Migrating from FM18L08 to FM28V020

AN108 discusses the key differences that need to be considered when migrating from FM18L08 to FM28V020. FM18L08 is now obsolete and this application note explains how FM28V020 is a replacement for FM18L08.

Figure 1. Difference in Response to Address Change (Read Cycle)

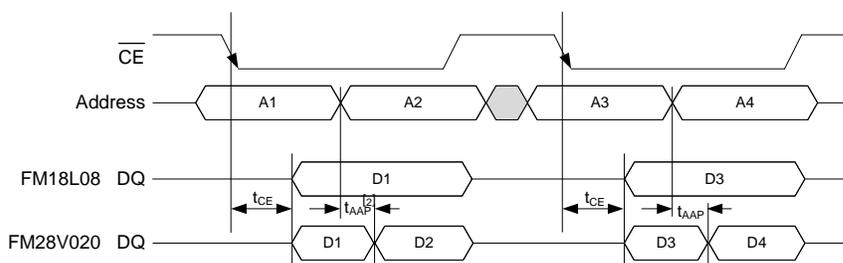
Note:
2. t_{AAP} is the page mode address access time. FM18L08 does not have page mode feature.

The FM28V020 supports page mode access while the FM18L08 doesn't. This could pose an issue in systems that change the address in the middle of an access. In such systems, when FM18L08 is replaced by FM28V020, the output data could change in the middle of an access. System designers should consider this during migration.

The FM28V020 requires a longer address hold time to avoid page mode access. It is 70 ns in FM28V020 compared to 15 ns in FM18L08. Most systems will hold the address stable throughout the entire cycle but this timing parameter should be considered during migration.
